PROTEST- PETITION
This form may also be used for objections

**PETITION FOR TIME EXTENSION, CHANGE, TEMPORARY URGENT CHANGE OR
TRANSFER ON**

APPLICATION ____ **PERMIT** DWR permits 16478, 16479, 16481, 16482 and
Reclamation permits 11315, 11316, 12721, 12722, 12723, 11967, 11968, 11969, 11971,
11973, and 12364

Re: Proposed Changes to the Bay Delta Conservation Plan/California WaterFix Continue to Threaten the Delta, Time for Plan "B"

Figure B-1: Daily EC values at Barker Slough from the sensitivity analyses for the period October 1976 through September 1984.

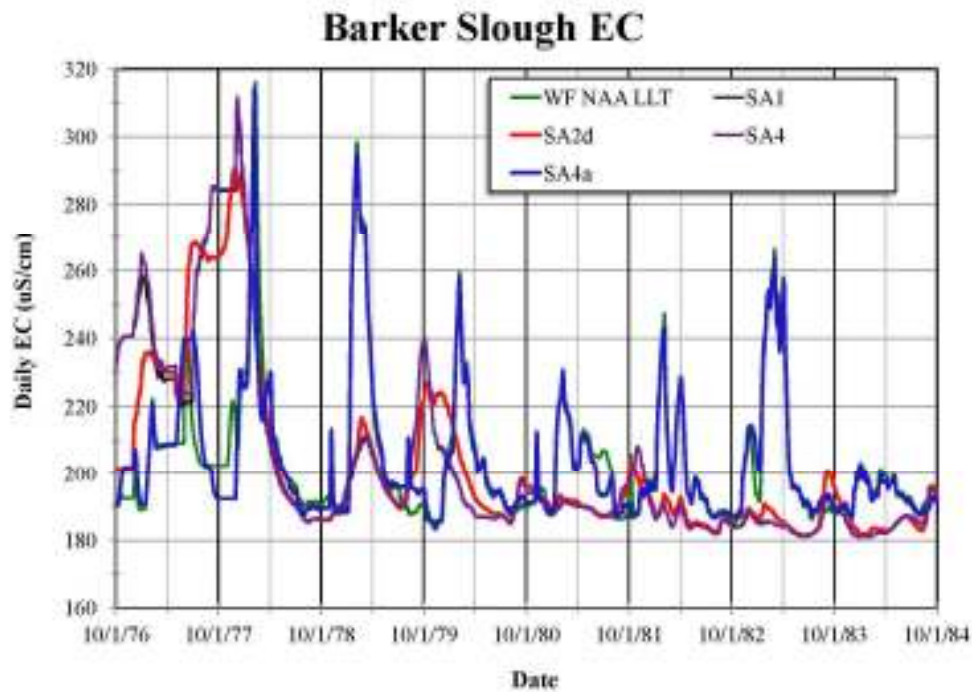
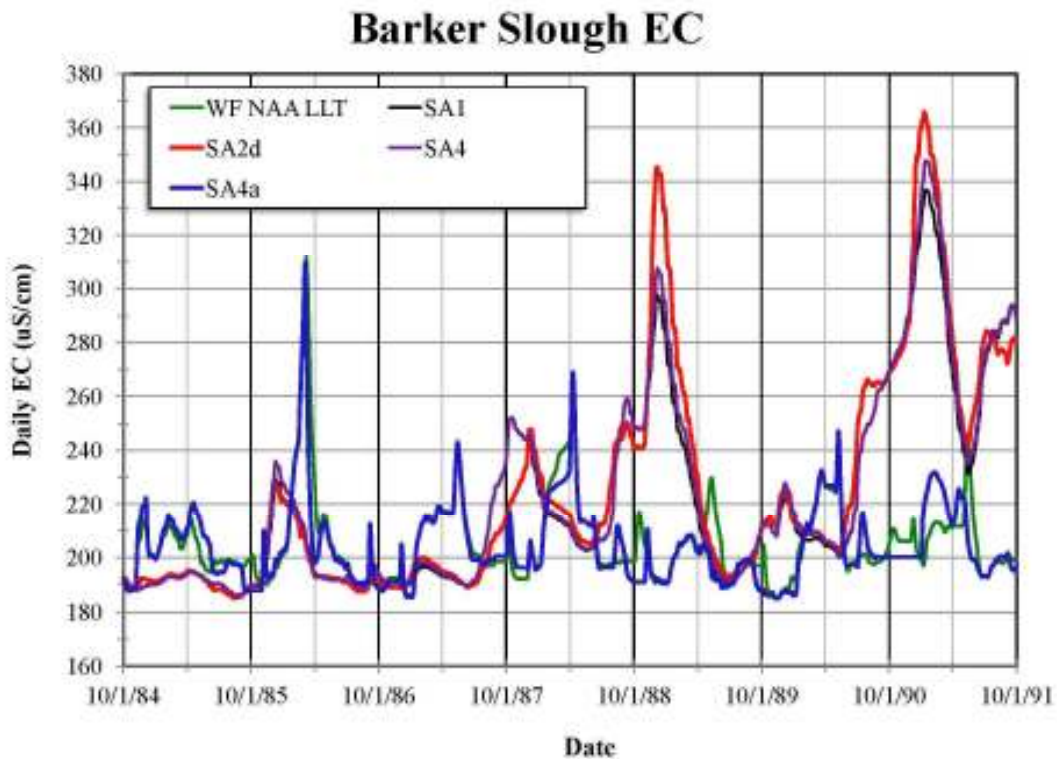
As shown in Figure B-1 and Figure B-2, removing the 65,000 acres of habitat restoration could reduce EC at Barker Slough during drought periods (relative to the BDCP Draft EIR/EIS proposed project, SA1) but increases EC significantly in normal and wetter years.

Figure B-3: Scatter plot of daily EC values at Barker Slough from the WaterFix sensitivity analyses with no restoration (SA4a, LLT) for the period October 1975 through September 1991. Some peak EC are reduced relative to the No Action equivalent but significant adverse impacts occur at other times.

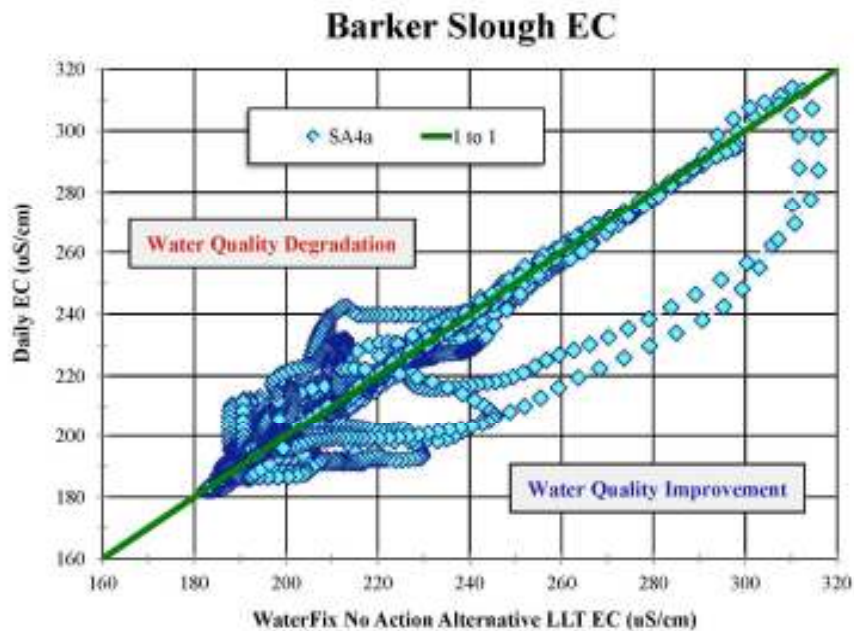
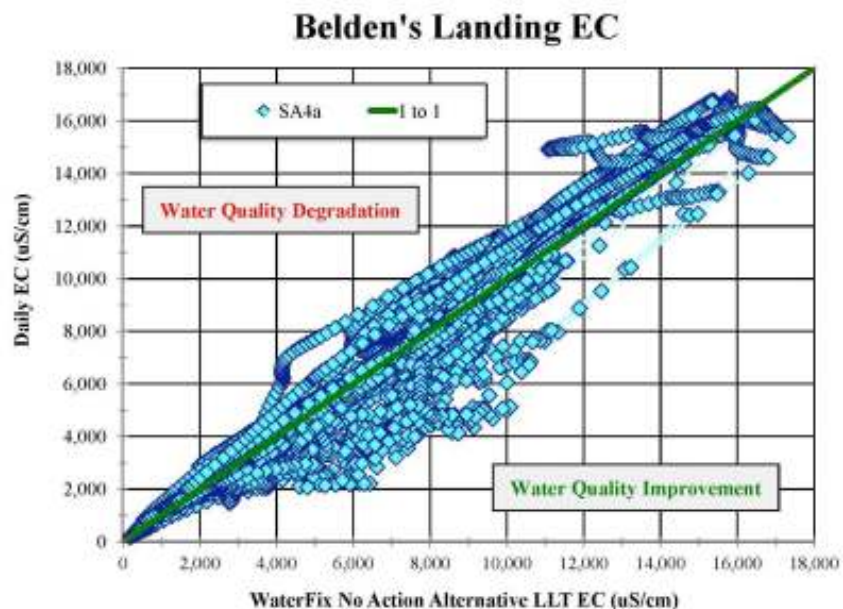
Figures B-3 and B-4 show the EC data for each month of the 16-year sensitivity analysis simulation period (192 data points) in the form of scatter plots. The EC data for Barker Slough and Belden's Landing for Sensitivity Analysis #4 (no habitat restoration) are plotted as a function of the WaterFix No Action Alternative and both are at late long term.

Some peak ECs at Barker Slough are reduced relative to the No Action equivalent but significant adverse impacts occur at other times. There are some reductions in EC relative to the No Action equivalent at Belden's Landing but significant adverse impacts occur at other times. The presentation of water quality data must present the data in sufficient detail to fully disclose the daily or month to month variations in water quality, in particular the occasions when salinities increase significantly. It is not acceptable to only present long-term averages that obscure and reduce the significant impacts on urban and agricultural water users, and the Delta ecosystem.

The RDEIR/SDEIS is inadequate because it fails to present analyses data in a form that discloses the daily or month to month impacts of the proposed project on water quality and fails to avoid or provide definitive mitigation for these significant impacts on water quality.

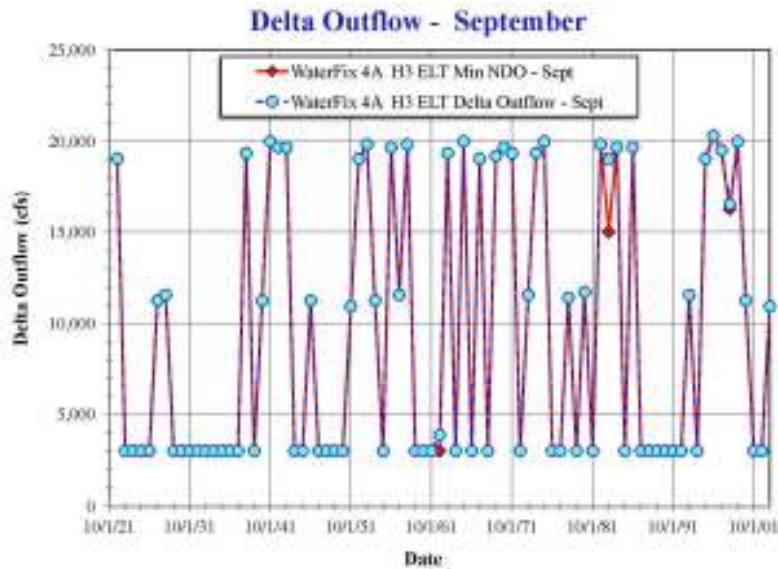
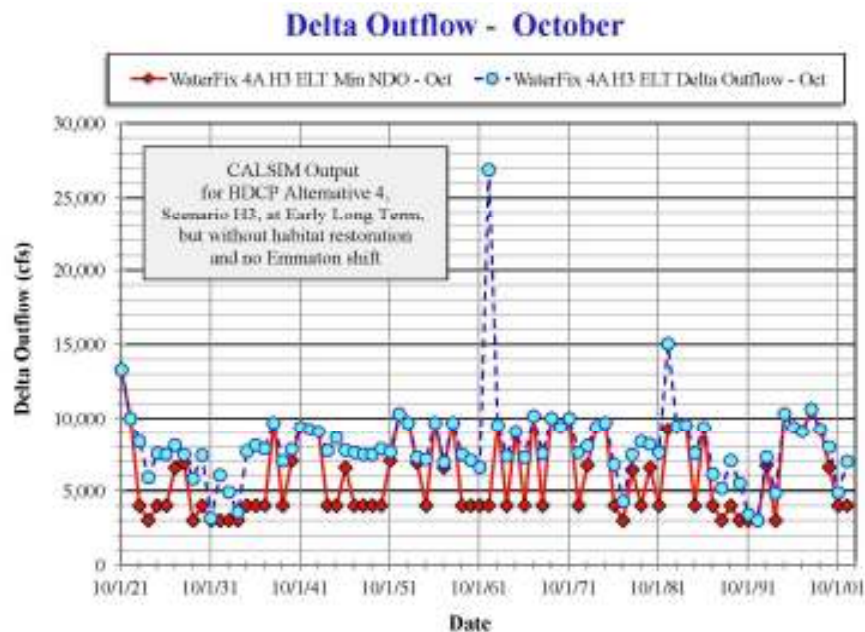
The outflows required to meet the Fall X2 requirement in September and October in the WaterFix analyses using CALSIM II, however, are very much larger. As shown in Figure B-5, the assumed minimum Delta outflows to meet X2 at Mallard Island (in wet years) and Collinsville (above normal years) are about 19,500 cfs and 11,500 cfs, respectively. These flows seem to be too high and may be artificially freshening the Delta during September and underestimating the water quality impacts of the proposed project. The reason for these high flows may be because the CALSIM II only attempts to meet September X2 requirements at the last minute, whereas increasing Delta outflows earlier will require much less Delta outflow.

Figure B-6 shows in the corresponding Delta outflows and minimum required Delta outflows for October. The October outflows are governed by the need to meet Fall X2 in wet and above normal years. Otherwise the D-1641 requirement of 3,000 cfs in critical years and 4,000 cfs in other water years applies. The flows assumed to be required to meet Fall X2 are consistent with the existing X2 outflow requirements. However, excess Delta outflows are occurring in many below normal, dry and critical years, which may underestimate the actual water quality impacts of the proposed project.

assumed to be required to meet Fall X2 are consistent with the existing X2 outflow requirements, but excess Delta outflows are occurring in drier years which may underestimate the actual water quality impacts of the proposed project.

The limited analysis of water quality impacts in the RDEIR/SDEIS is also inadequate because the reason for unexpectedly high Delta outflows in September to meet Fall X2 is not explained or justified. The real time operations of the proposed project would likely call for the start of increased flows to begin in August to meet the September Fall X2 requirements (to account for the delayed response between outflow and salinity in the western Delta) and require much less total outflow. The actual water quality impacts in September are likely to be higher than presented in the RDEIR/SDEIS so the real adverse impacts are not fully disclosed. Similarly, excess Delta outflows are being provided by the CALSIM II model in drier years in October which also underestimates the potential adverse water quality impacts in October.

A new Draft EIR/EIS must be prepared that corrects or justifies through detailed modeling and detailed data presentations, the apparent excessive Delta outflows in both September and October which cause water quality impacts to be under predicted. The new Draft EIR/EIS must then be released for public review and comment.

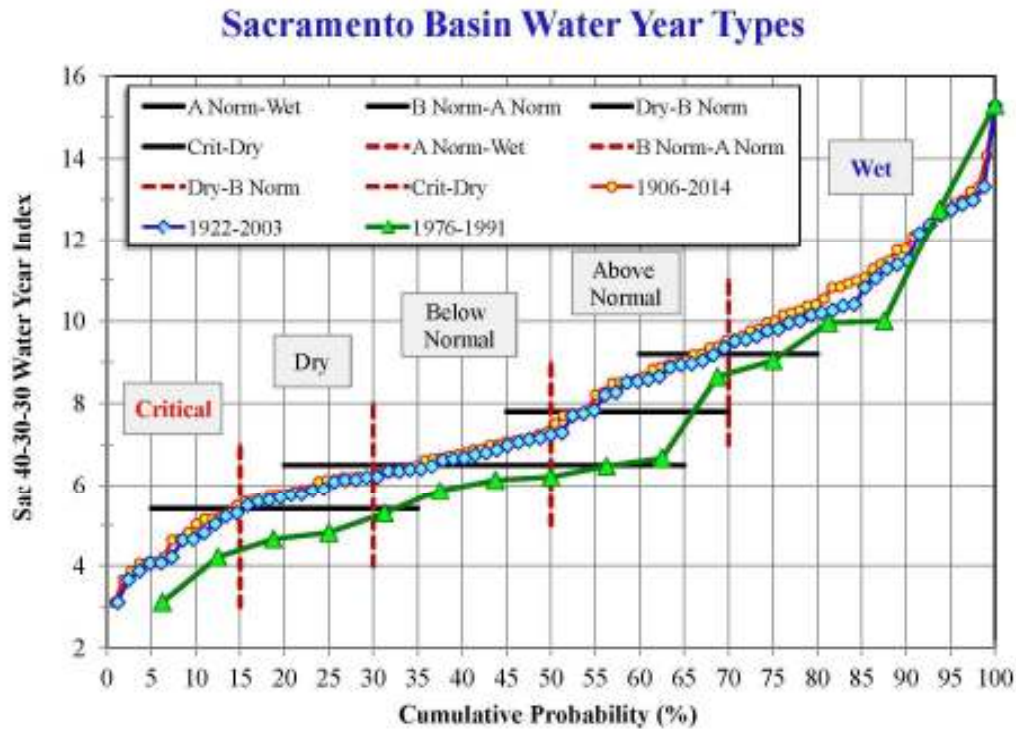
The water quality analyses are only performed and presented for the period October 1975 through September 1991 (16 years). This period contains two major droughts (1976-1977 and 1987-1991) but only the latter is used to represent the water quality changes under drought conditions. When the data are categorized by month and by water year type, the amount of data available to be averaged can be as few as 2-5 months of data. That is not sufficient data to develop a statistically significant representation of the variations by month and water year type.

Also as shown in Figure B-7, the water year 1976-1991 period is considerably drier than the full historical record (1906-2014) and the 1922-2003 period used for the Central Valley operations modeling using CALSIM II.

Figure C-1: Monthly total Delta exports as a function of Delta outflow for the WaterFix preferred alternative (Alternative 4A, Scenario H3 at Early Long Term). Only months when outflows are less than 30,000 cfs are plotted.

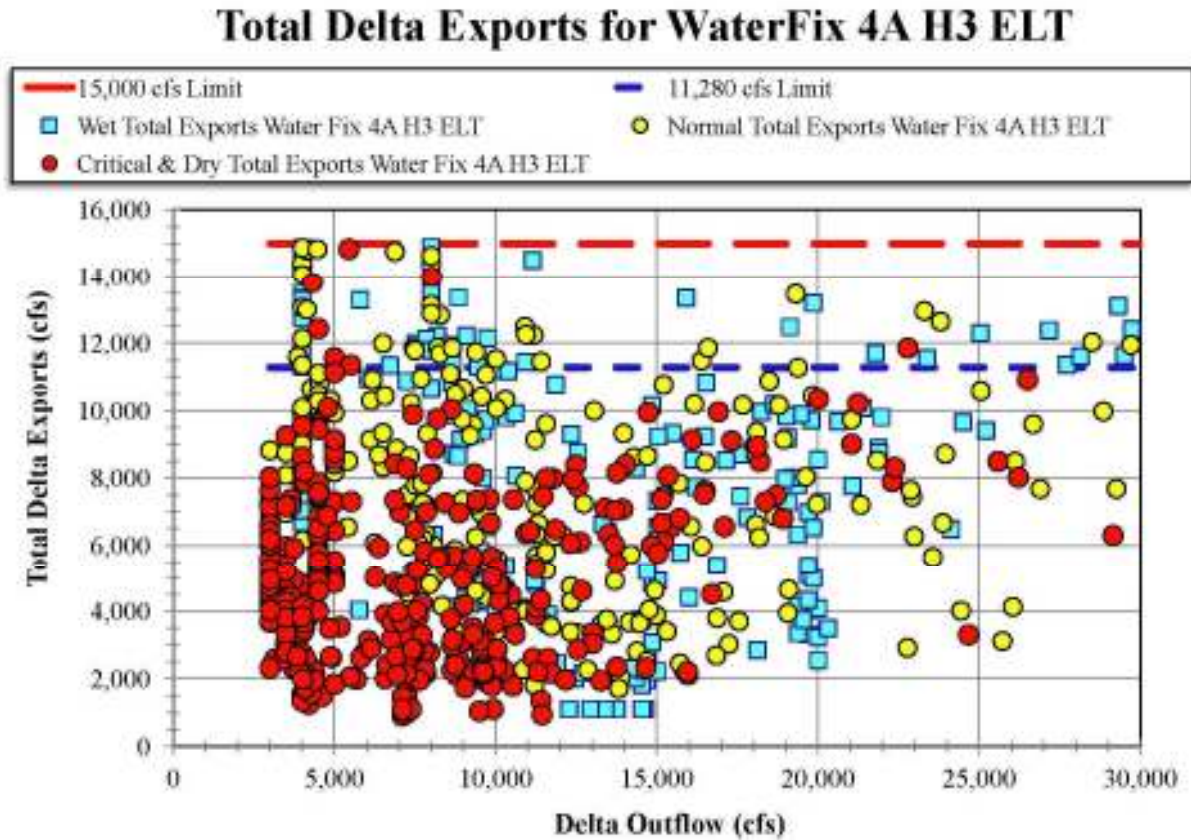
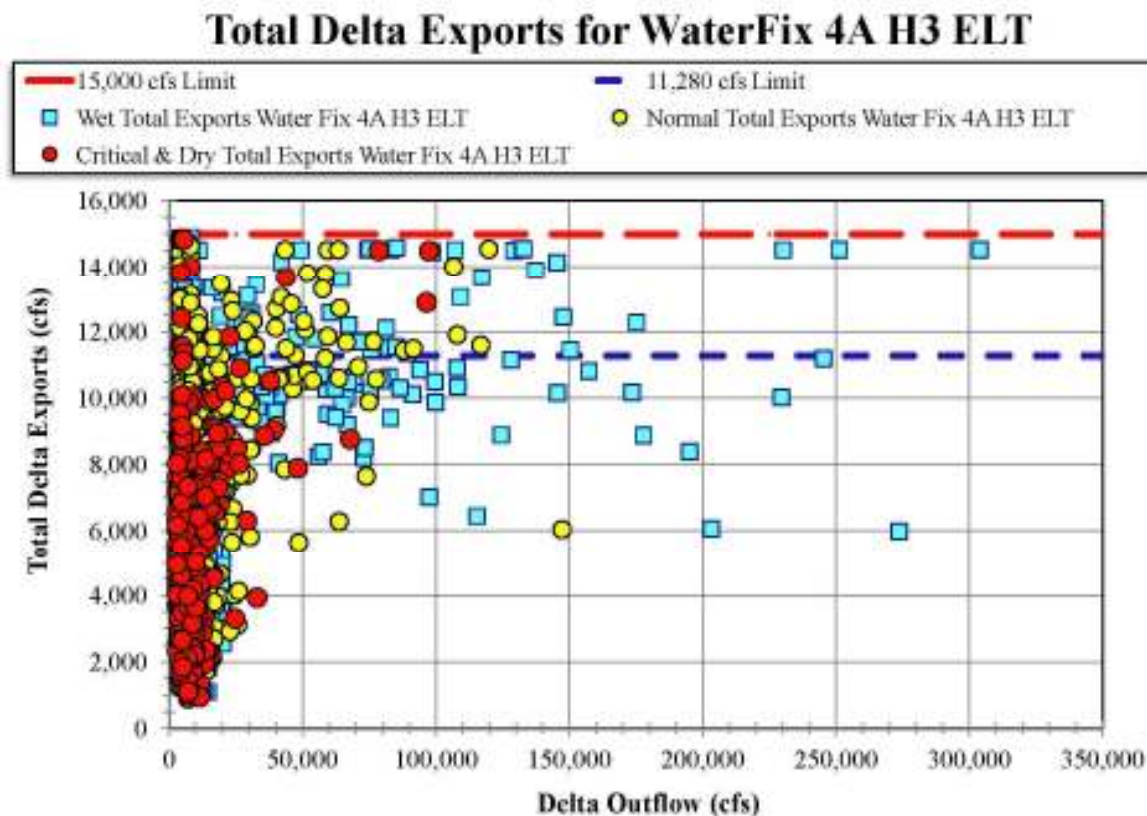
Currently, the maximum rate of exports from the Delta during drier periods is about 11,280 cubic feet per second (6,680 cfs at the SWP export facility plus 4,600 cfs at the CVP pumps.). As shown in Figure C-1, the WaterFix data for Alternative 4A, Scenario H3 at early long term, suggest that in many dry months when Delta outflows are very low, the combined SWP and CVP exports from the south Delta would be as high as 14,900 cfs. This is an increase in south Delta pumping of 3,600 cfs or about 24%.

Rather than diverting less in dry periods and reducing the CVP and SWP’s dependence on water from the Delta, the WaterFix project would increase exports.

The same WaterFix operations simulations show that during periods of high Delta outflow (say 30,000 cfs or greater), when water surplus to the needs of the Delta could be available for export, the WaterFix preferred alternative often fails to increase in export diversions above existing levels (Figure C-2). In other words, without new storage in or close to the Delta, the WaterFix preferred alternative is unable to capture this surplus flow. During wet periods, farmers' fields and urban landscapes are soaked reducing demand for water. The existing south-of-Delta reservoirs fill and there is nowhere else to quickly store the more water. The WaterFix preferred alternative will be unable to regularly take a "Big Gulp."

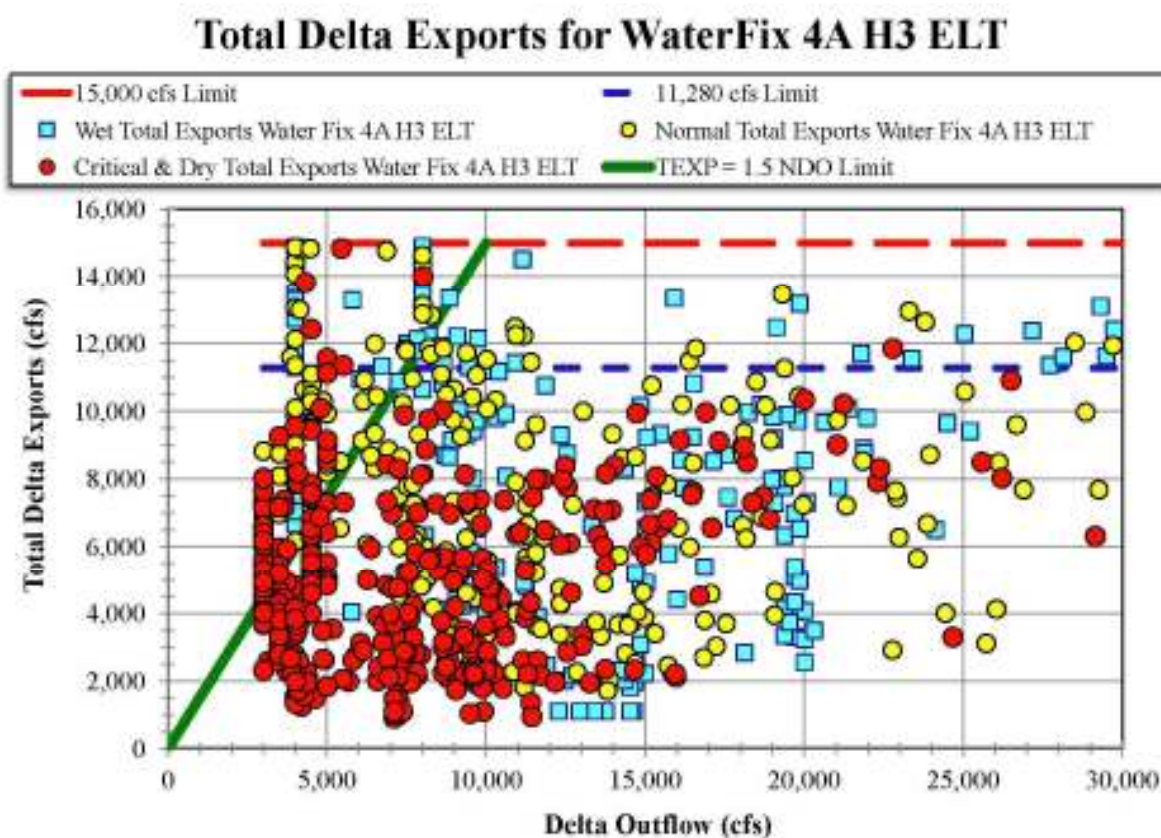
Figure C-3 shows the same data as Figure C-1 but this figure also shows a limit on total CVP and SWP exports of the form: total exports = 1.5 x Delta outflow.

This would mean that in the fall when outflows are only 3,000 cfs, only 4,500 cfs can be exported. The CVP and SWP would not be able to increase exports above existing levels unless Delta outflow was 7,500 cfs or greater. The resulting loss of export water would have to be made up during periods of higher Delta outflow. That will not be possible though without new storage and other infrastructure in the Delta to capture more water during higher flow periods.

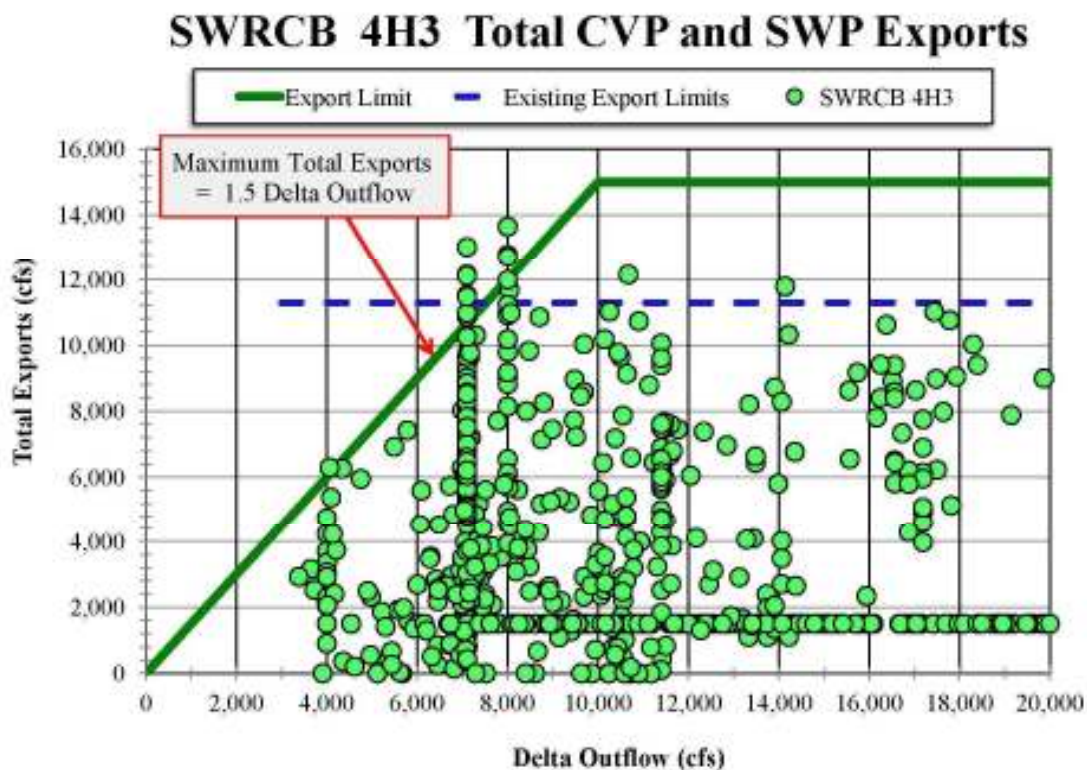
According to Appendix C of the RDEIR/SDEIS, the SWRCB requested that an additional alternative be analyzed (4H3) which would be operated to much higher Delta outflow

requirements specified by the SWRCB. Unfortunately, DWR and Reclamation did not modify the WaterFix infrastructure to adapt to these higher outflow requirements so the environmental benefits and viability (with respect to cost and water supply benefits) of a higher Delta flow alternative were not tested and disclosed. It is interesting, however, that the corresponding total exports versus Delta outflow graph for SWRCB Alternative 4H3 shown in Figure C-3 does represent less water being exported in drier periods. The reduced exports in this SWRCB alternative are consistent with the suggested low outflow export limit (total exports = 1.5 x Delta outflow).

A new Draft EIR/EIS should be prepared that includes more holistic alternatives that reduce exports during drier months (e.g., in a fashion similar to the suggested exports = 1.5 inflow limit) and are able to capture “new” water during periods of high Delta outflow. That would contribute to achieving the coequal goals as well as improving water quality in the Delta. The dismal WaterFix proposal hinders any progress to achieving these goals. The new Draft EIR/EIS should then be released for public review and comment.
